# MEMORANDUM

DATE: September 17, 1987

SUBJECT: Seward Peninsula  
Field Trip,  
6/22-26/87

FROM: Alan Townsend and *APM*  
Robert McLean *McL*  
Habitat Biologists  
Habitat Division  
Department of Fish and Game

#### DAVID CREEK

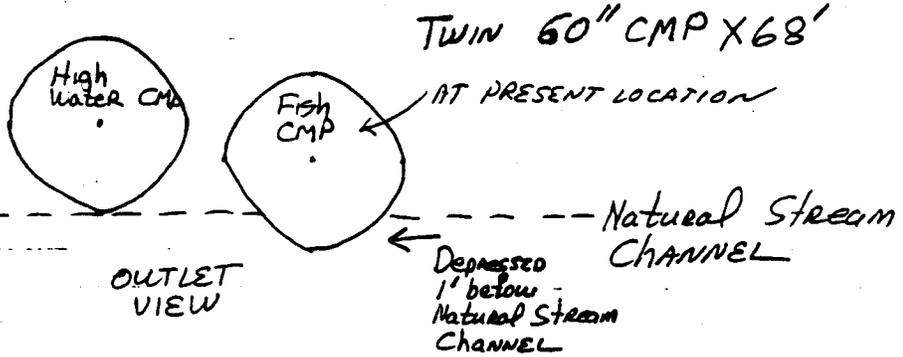
- ° Inspected 6/22/87 by 2122 hours.
- ° Same culvert in place as in 1986.

- Timber which was partially blocking the culvert inlet in 1986 was gone.
- Inlet contraction was resulting in an approximate 2 foot high headwall.
- Outlet invert perched approximately 18 to 24" above stream thalweg.
- Inlet armor beginning to fail.
